51ST BRIGADE IRAQI ARMY BARRACKS
AL HILLAH, IRAQ

SIGIR PA-06-075
JANUARY 29, 2007

SUBJECT: Report on 51st Brigade Iraqi Army Barracks, Al Hillah, Iraq
(Report Number SIGIR PA-06-075)

Site Photo 5. Aluminum doors at front entrance to the barracks sleeping quarters

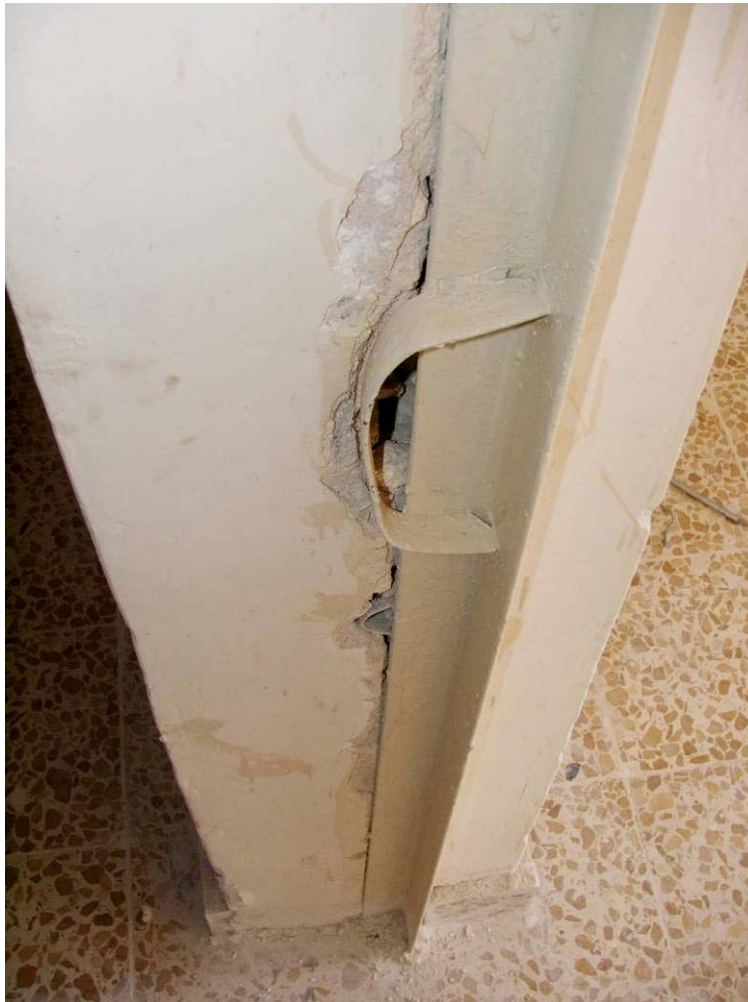
The SOW also required “good quality” aluminum windows and aluminum doors in the barracks sleeping quarters. In our inspection, we observed two sets of aluminum entry/exit doors in the sleeping quarters, one set of double doors serving as the front entrance, and a single door in the rear of the building. These doors did not appear to be “good quality,” especially considering the high traffic that a 75-man barracks will receive. Site Photo 5 shows the aluminum doors used for the entrance to the barracks sleeping quarters, and Site Photo 6 shows the rear entrance/exit door in one of the two barracks.

Site Photo 9. Shower in ablution buildings

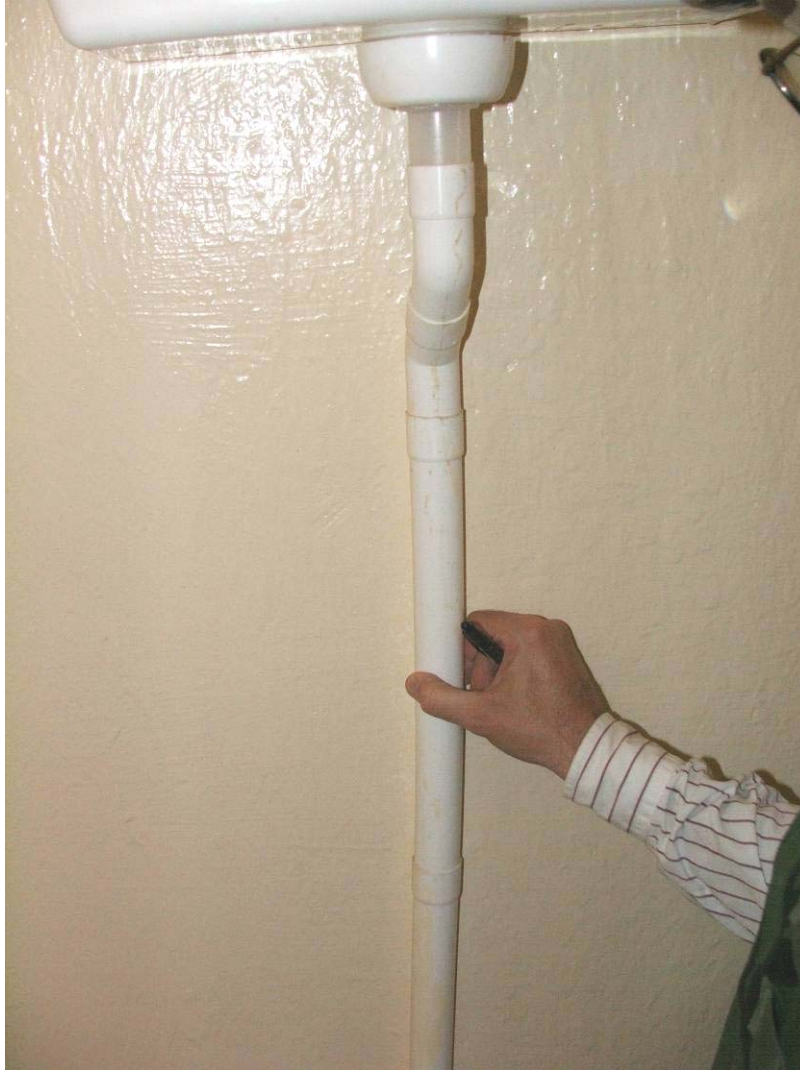
Regarding the plumbing fixtures used in the ablution buildings, we did observe what appeared to be low quality fixtures (shower heads, water supply lines, faucets, drain covers, etc.) installed in the showers, wash stations, and water closets. Site Photos 9 and 10 show the shower fixtures, including the shower head and the thin metallic tubing used to supply water to the shower head. Site Photos 11 and 12 show the type of plumbing materials used in the water closets, which includes flexible water hoses, plastic supply tanks, and thin wall plastic tubing supplying water from the tank to the toilet. Considering the ablution buildings will receive heavy usage, we believe the low quality plumbing fixtures will pose continual maintenance problems for the Iraqi Army.

Figure 1. Design detail for covered parking (sunshade)

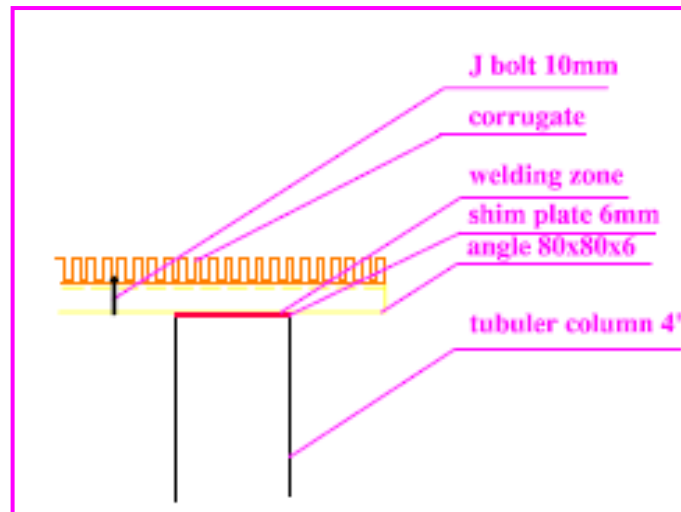
The design detail for the structural frame supporting the corrugated roof sheeting (Figure 1) showed an 80 x 80 x 6 angle supporting the roof sheeting. No units were provided for the angle, although it is assumed the dimensions are in millimeters. Figure 1 also shows the angle welded to a shim plate at the top of the column. There were no details provided on the type or size of weld or the type and thickness of the corrugated roof sheeting. The design also did not show any lateral cross bracing perpendicular to the angle support shown in Figure 1.

Site Photo 14 shows the actual welded angle connections at the bearing plate (i.e., shim plate) at the top of each tubular column, as well as, the lateral cross bracing. The roof sheeting material appeared to be a thin gage sheet metal, connected to the frame with J-bolts, as depicted in Figure 1.

Site Photo 15. Torn sheeting at one end of the parking sunshade

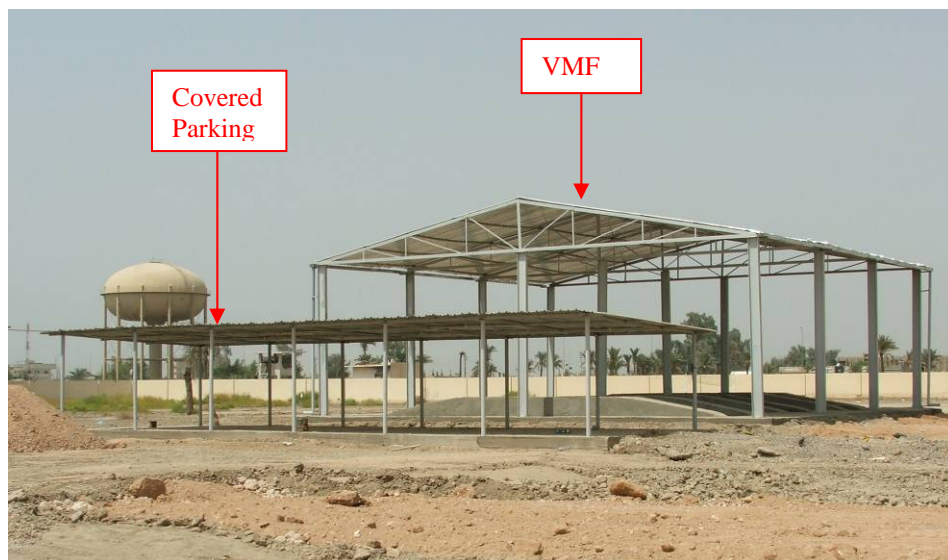
At one end of the sunshades, a portion of the metal sheeting was torn away at the corner (Site Photo 15). We also observed broken concrete at the base of one of the four inch tubular columns (Site Photo 16). Both of these items should be included in the punch list generated at final inspection.

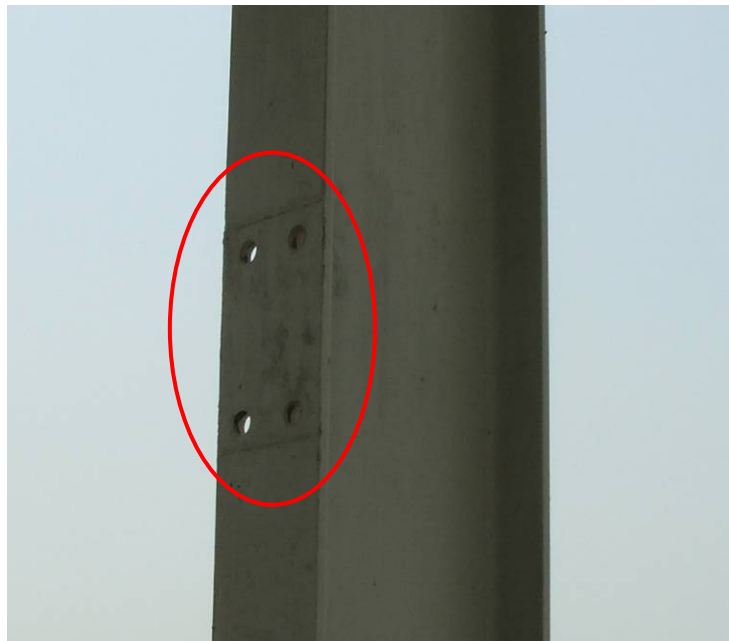
The motor pool structure was supported by 12 steel H-columns. Each column was welded to a base plate, which was attached to the concrete floor slab using four anchor

bolts cast in the concrete. On one of the 12 columns, we found on one anchor, the nut connecting the anchor bolt to the base plate resting on the top of the bolt. The nut needed to be tightened down to the base plate.

We also observed one of the H-columns consisted of two sections, butt welded together to form the column (Site Photo 21). In addition, in two of the 12 columns, we observed four bolt holes in the flange section of the column (Site Photo 22).
